AMENDMENT OF SOLICITATION/MODIFICATION OF CONTRACT				1. CONTRACT ID CODE	Page 1 of 3
2. AMENDMENT/MODIFICATION NO. 0004	3. EFFECTIVE DATE 08/11/2010	4. REQUISITION/PURCHASE REQ. NO.	5. PROJECT NO. (If applicable)		
6. ISSUED BY Bureau of Reclamation - GP-3800 316 North 26th Street Billings, MT 59101		CODE 00060	7. ADMINISTERED BY (If other than Item 6) Bureau of Reclamation - GP-5000 316 North 26th Street Billings, MT 59101		CODE 00060
8. NAME AND ADDRESS OF CONTRACTOR (No., street, county, State and Zip Code) No Contractor Information Available			(X)	9A. AMENDMENT OF SOLICITATION NO. R10PS60186	
			(X)	9B. DATED (SEE ITEM 11) 06/17/2010	
				10A. MODIFICATION OF CONTRACT/ORDER NO.	
				10B. DATED (SEE ITEM 13)	
CODE		FACILITY CODE

Project Title: Glendo Dam Modification, Oregon Trail Division, Glendo Unit, Pick-Sloan Missouri Basin Program, Wyoming

Description of Change(s):

Solicitation No. R10PS60186
Glendo Dam Modification
Questions and Answers

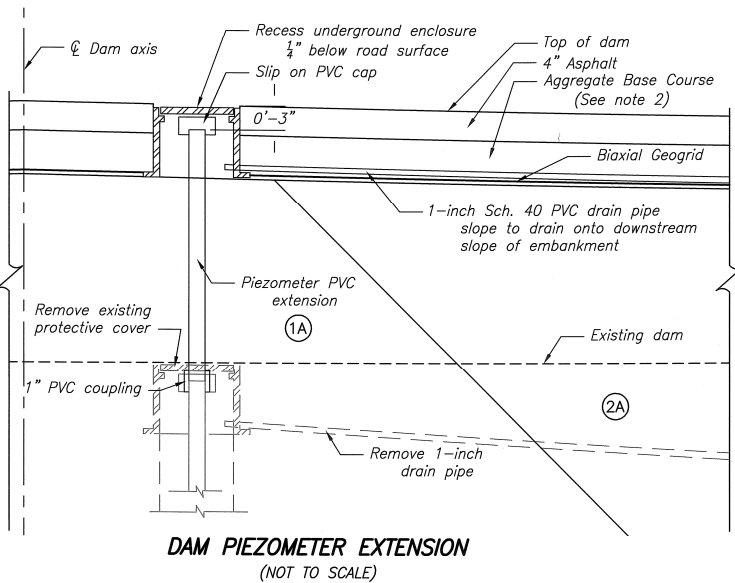
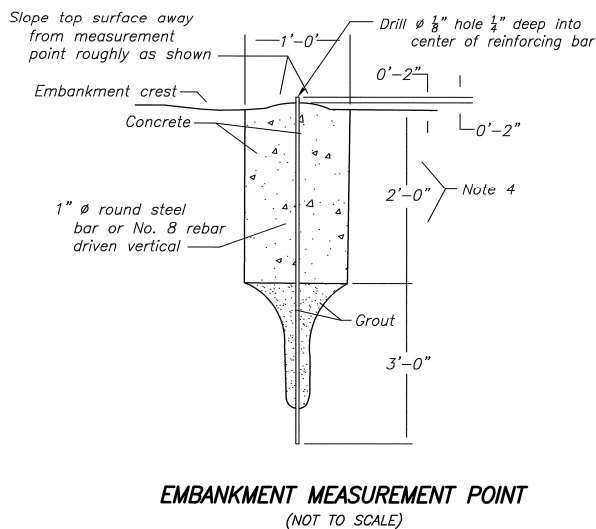
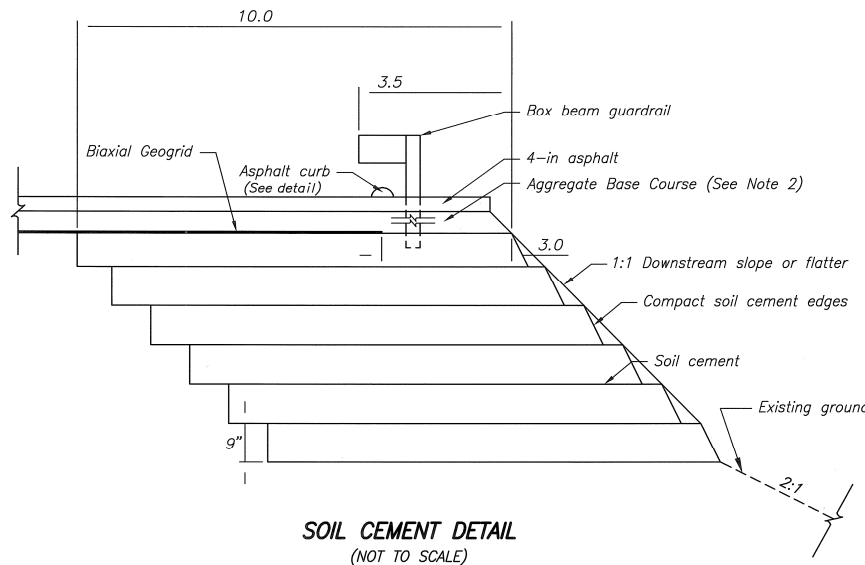
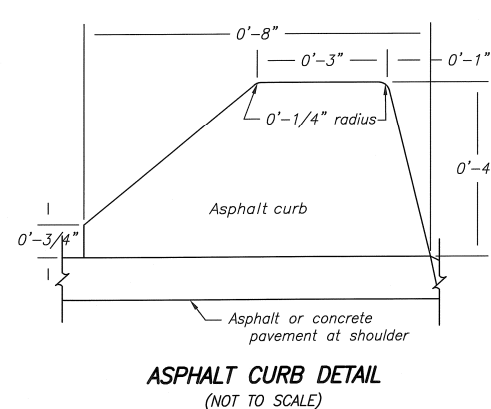
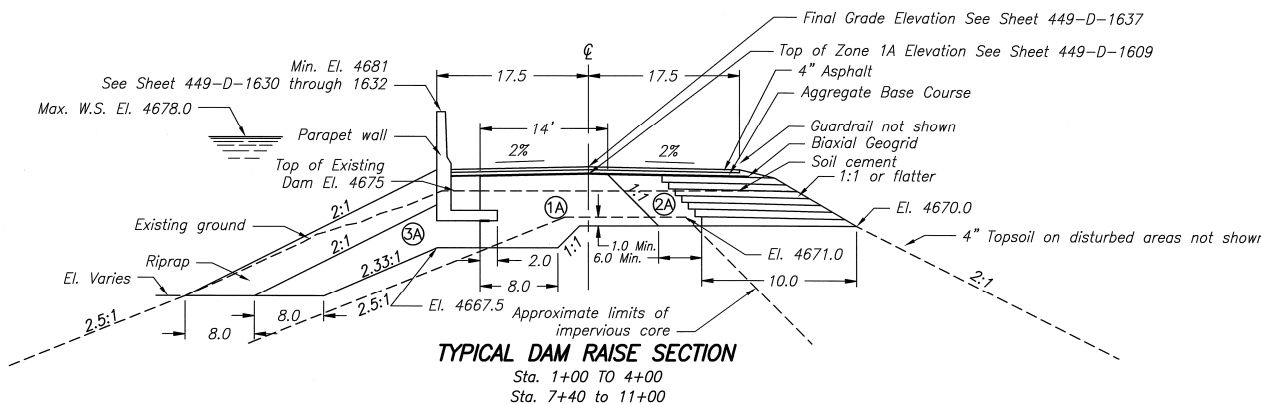
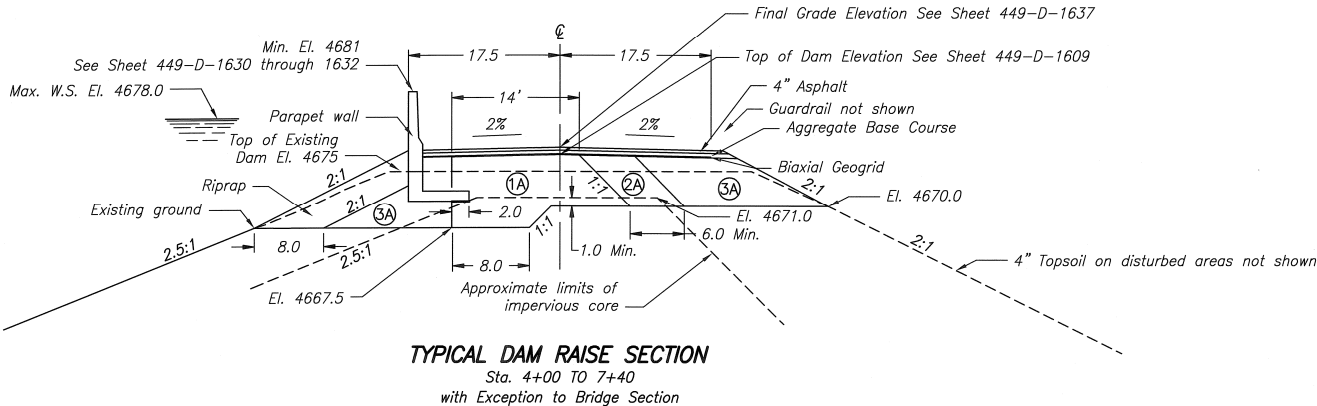
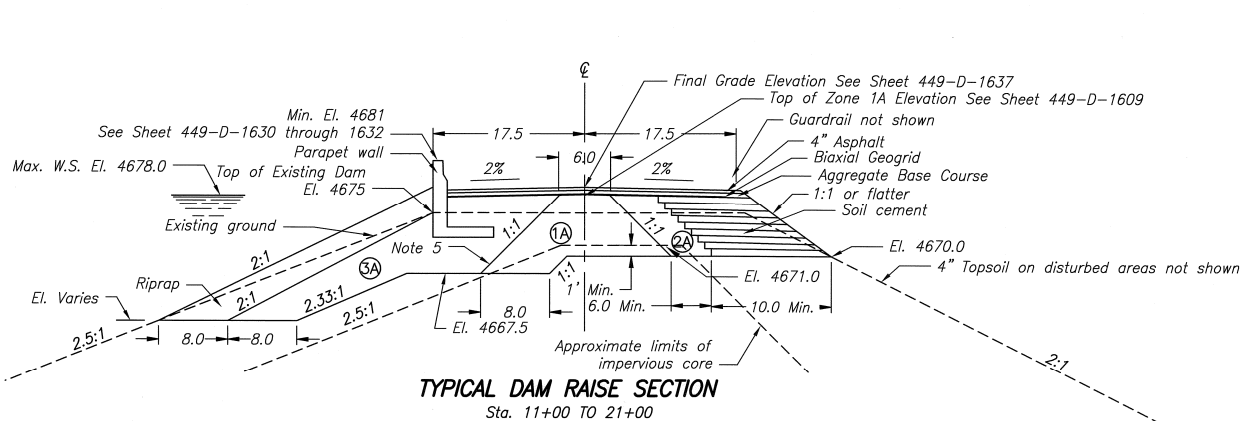
3. *On sheet 1606 Material Distribution Chart, it shows wasting all of the excavation, and borrowing all the material needed for embankment of associated items. However on Sheets 1608, 1609, and 1615, the notes indicate that suitable excavation can be used as fill. Is it the intention of the BOR to pay for the material under the associated excavation and borrow items when it is used for embankment?*

REV NO 1 2010-07-26 Updated Material Quantities
D. C. Strickland, P.E. Jeffrey Warner, P.E.

Response: In accordance with the note on the drawing and Section 51 00 30 – Earth Materials Distribution Diagram, Paragraph 1.01.C: “The provided earth materials distribution diagram is solely for information of the Contractor. Data on diagram is intended to be used only as a guide.” Suitable excavated material may be approved by Reclamation and used as certain fill materials per the Specifications.

DESIGNED	WILLIAM DRESSEL	CHECKED	CARLY M. WEGHER
DRAWN	WILLIAM DRESSEL	TECH. APPR.	DANIEL D. MARES, P.E.
APPROVED	JOHN H. LABOON, P.E.		
PEER REVIEWER	JOHN H. LABOON - MANAGER, WATERWAYS AND CONCRETE DAMS GROUP		
DENVER, COLORADO	2010-02-26		449-D-1618
	SHEET 1 OF 1

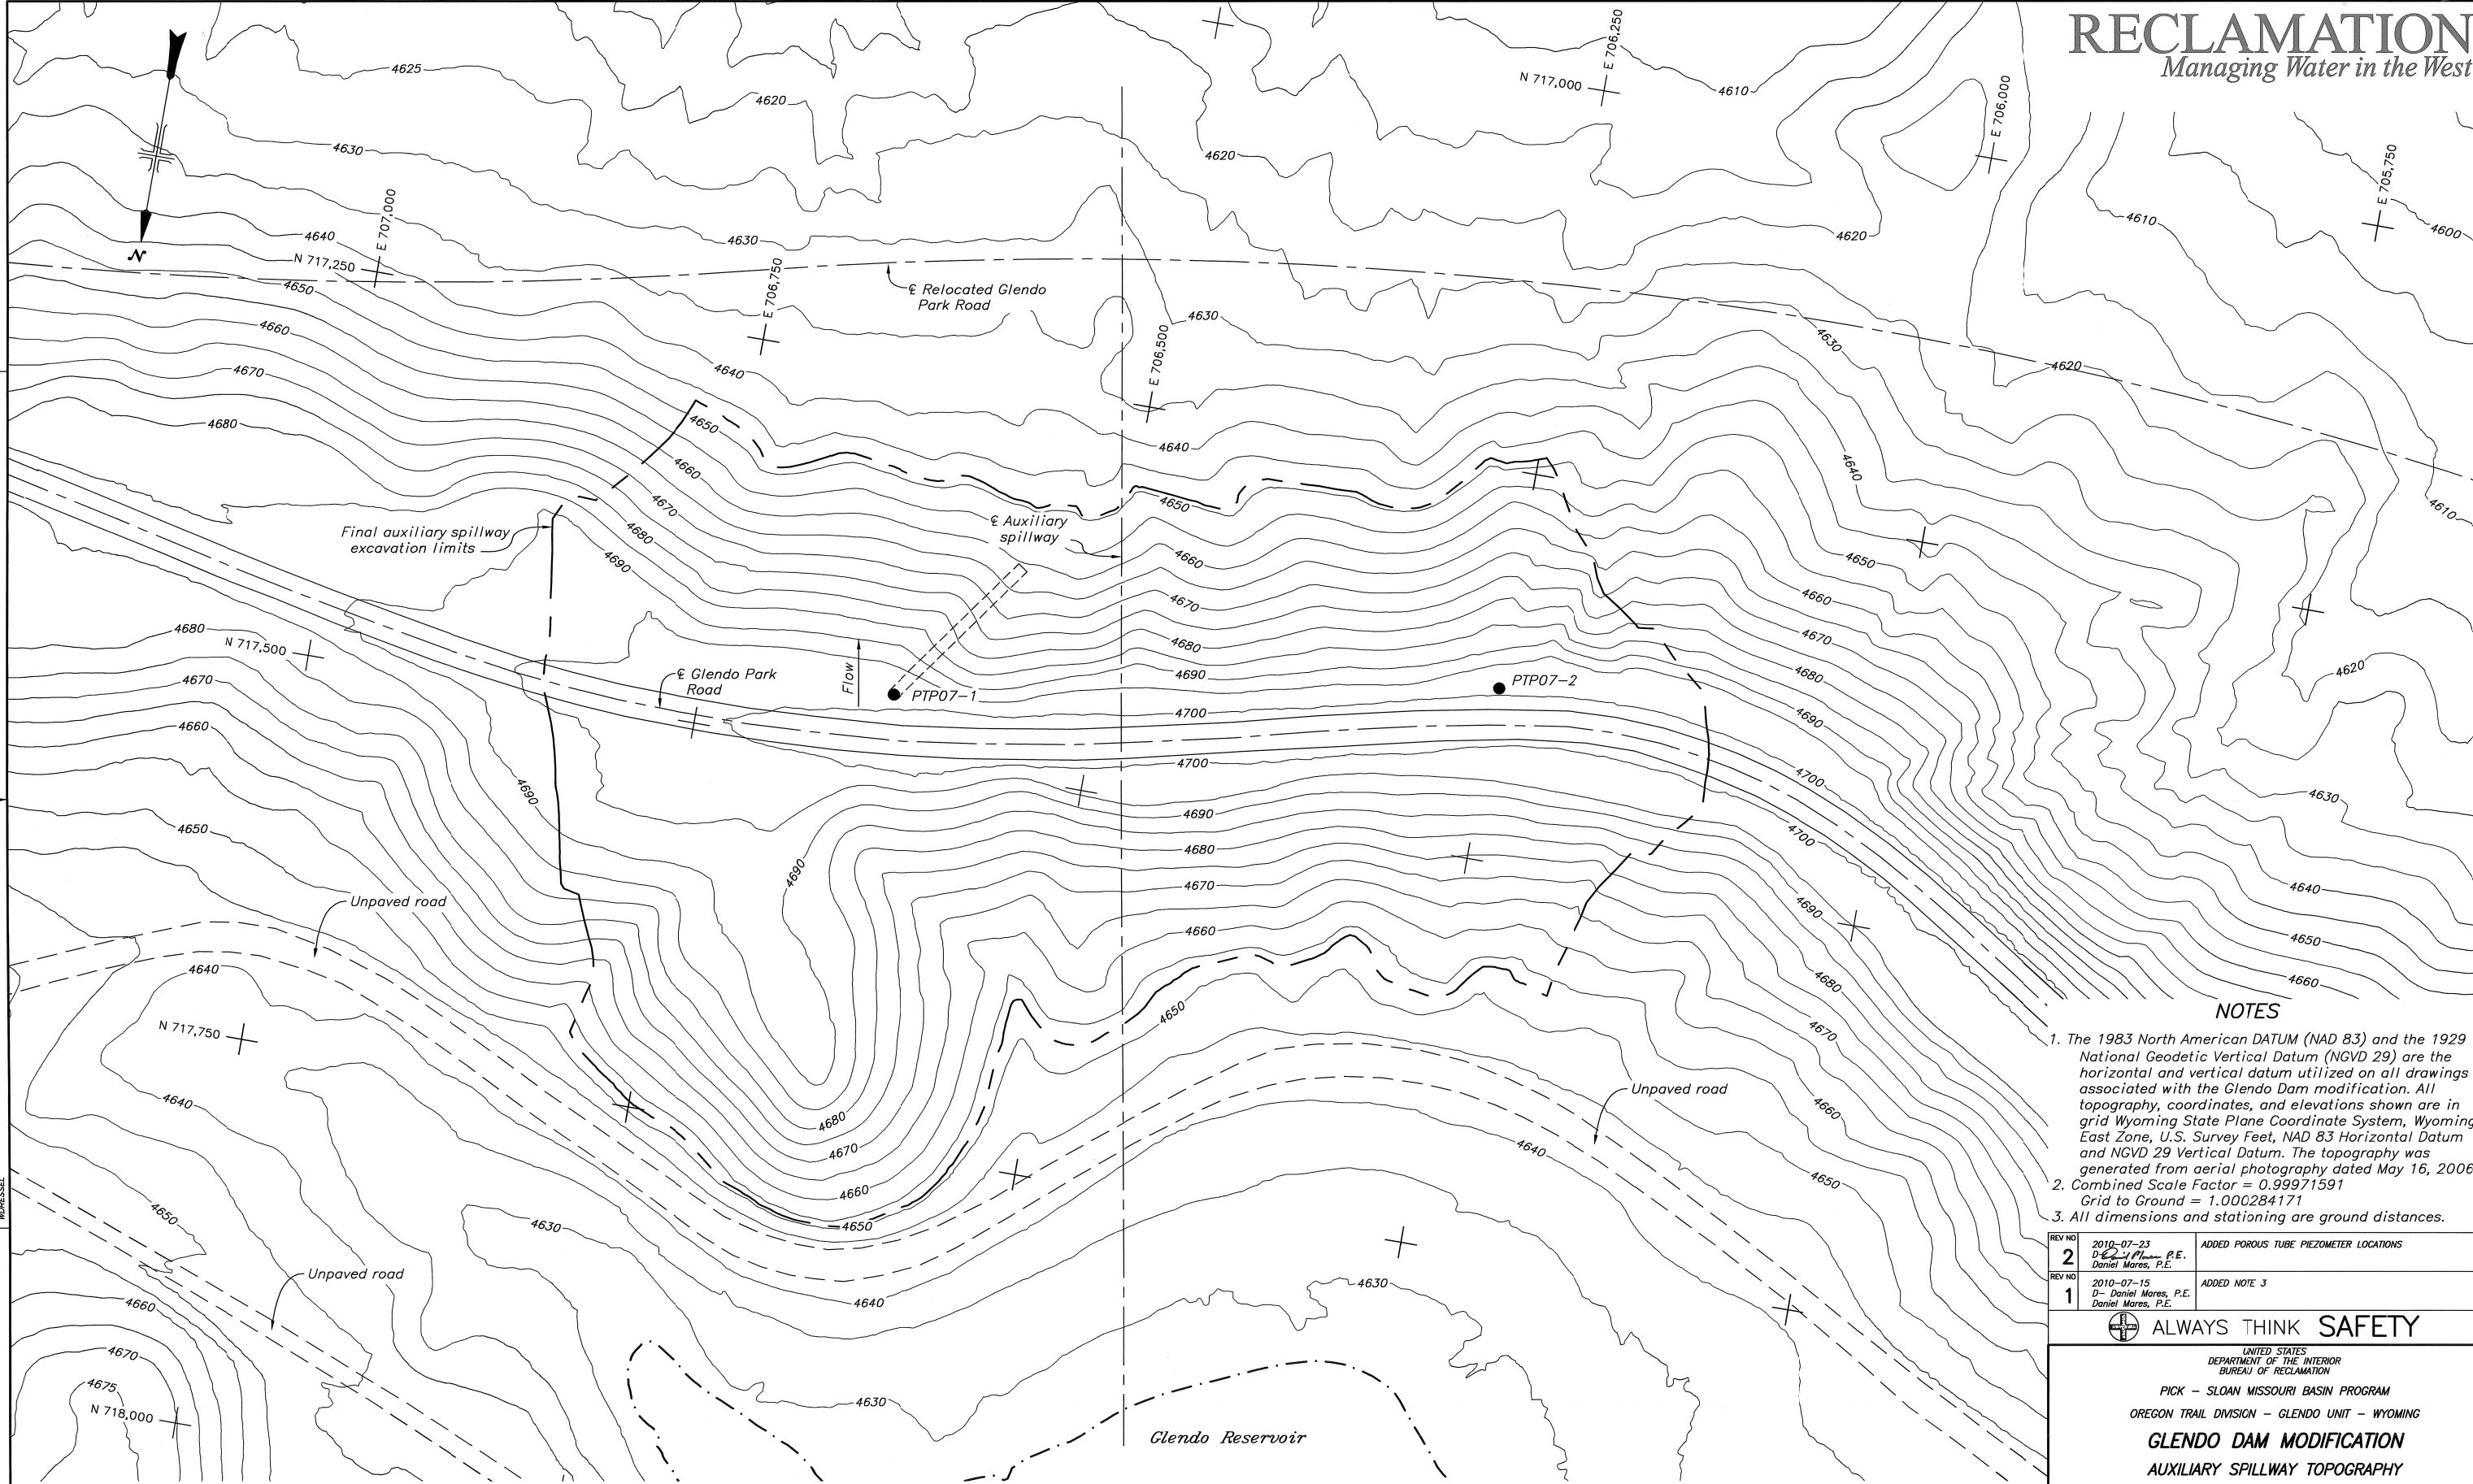
13. *Where do we find out information on Existing Piezometers that have to be abandoned, Depth and Number of them?*

Response: The existing piezometers that will be abandoned or removed are located at the auxiliary spillway site. Drill Hole DH07-1 and DH07-5 were completed as porous tube piezometers PTP07-1 and PTP07-2 respectively. Information on the depth and number of piezometers at the auxiliary spillway site can be found in Section 53 10 00 – Geologic Investigations and drawing 449-D-1645 in Volume III of the Glendo Dam Modification Specifications. Drawing 449-D-1618 will be amended to show the location of the piezometers to be abandoned.

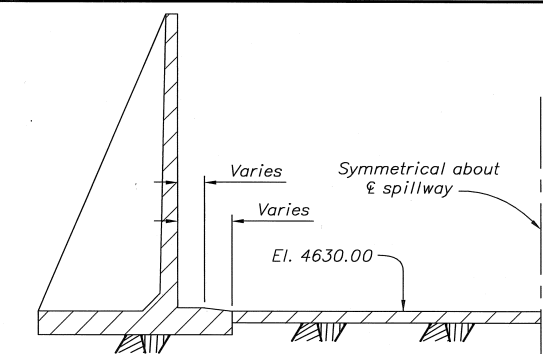
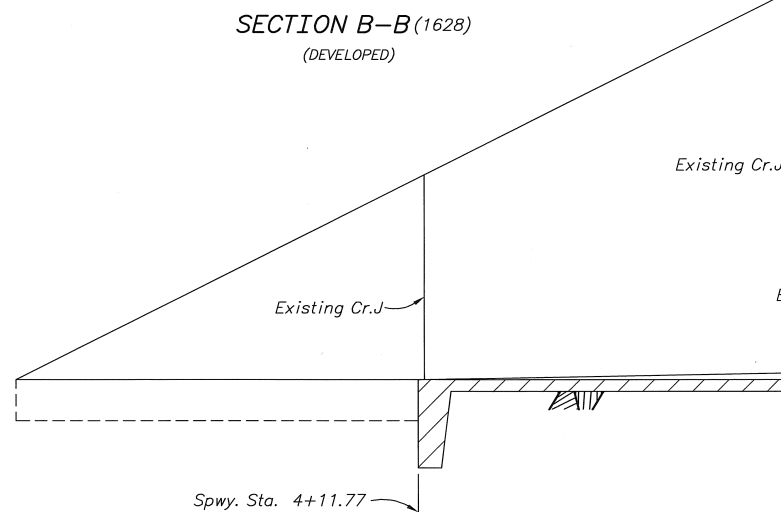
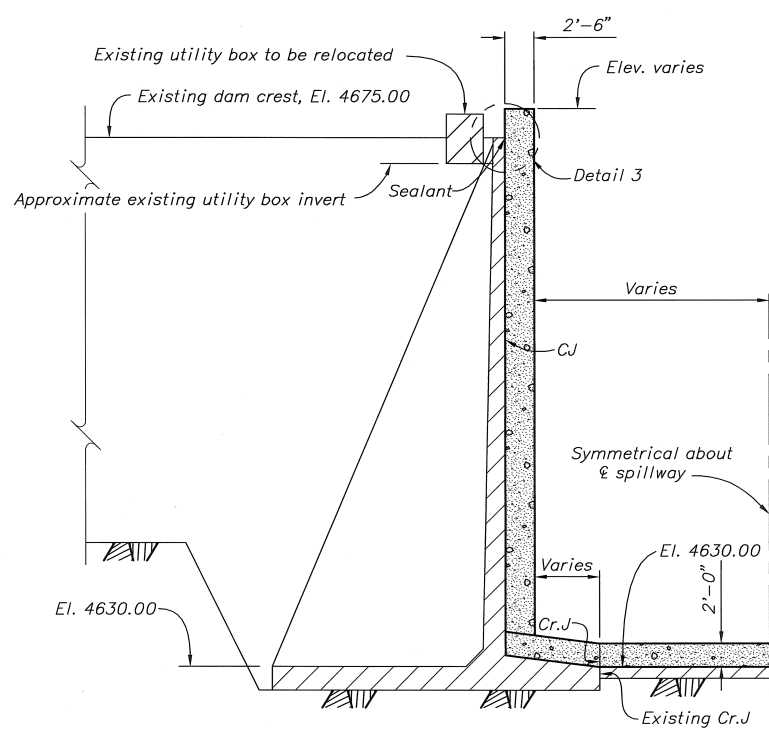
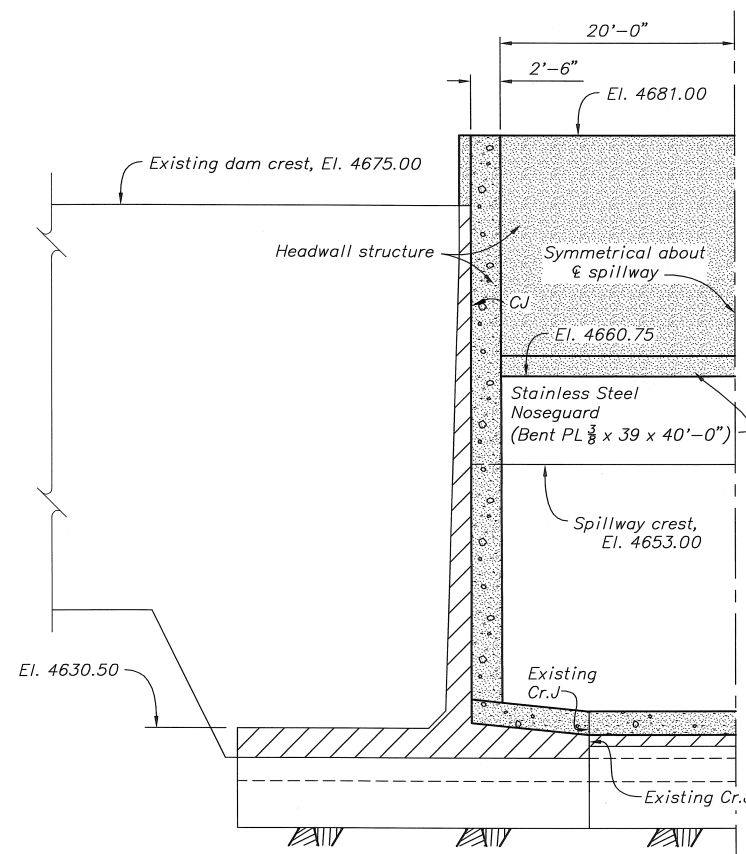
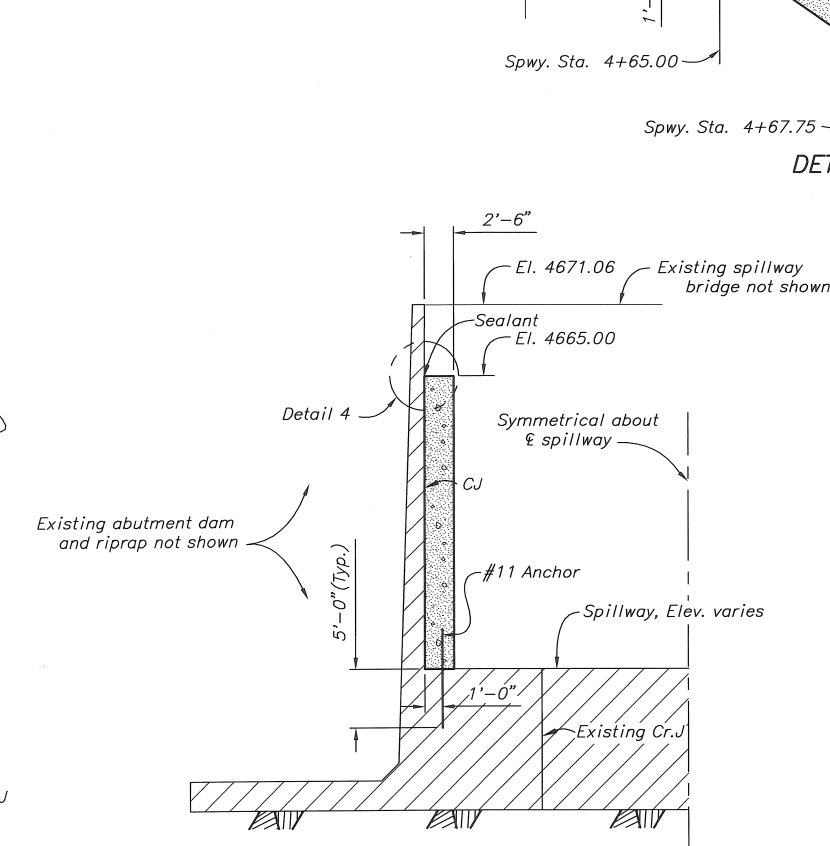
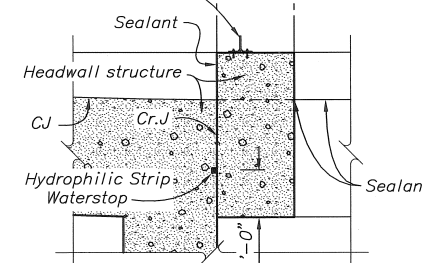
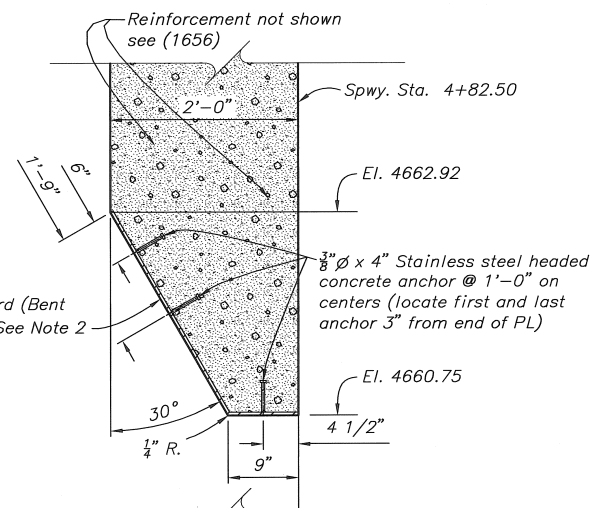
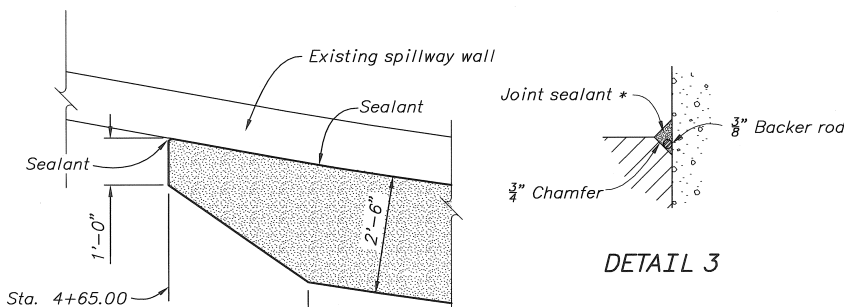
REV NO 1	2010-08-09 D. Mares, P.E.	ADDED NOTE 2 AND DETAILS 3 AND 4.
<p>ALWAYS THINK SAFETY</p> <p>UNITED STATES DEPARTMENT OF THE INTERIOR BUREAU OF RECLAMATION PICK - SLOAN MISSOURI BASIN PROGRAM OREGON TRAIL DIVISION - GLENDO UNIT - WYOMING GLENDO DAM MODIFICATION SERVICE SPILLWAY HEADWALL STRUCTURE PROFILE AND SECTIONS</p>		
DESIGNED HILLERY VENTURINI	CHECKED JOHN ELLINGSON, P.E.	
DRAWN J.E. MARKLEY	TECH. APPR. DANIEL D. MARES, P.E.	
<p>APPROVED JOHN H. LABOON, P.E. PEER REVIEWER - JOHN H. LABOON - MANAGER, WATERWAYS AND CONCRETE DAMS GROUP DENVER, COLORADO SHEET 2 OF 2</p>		
		449-D-1629
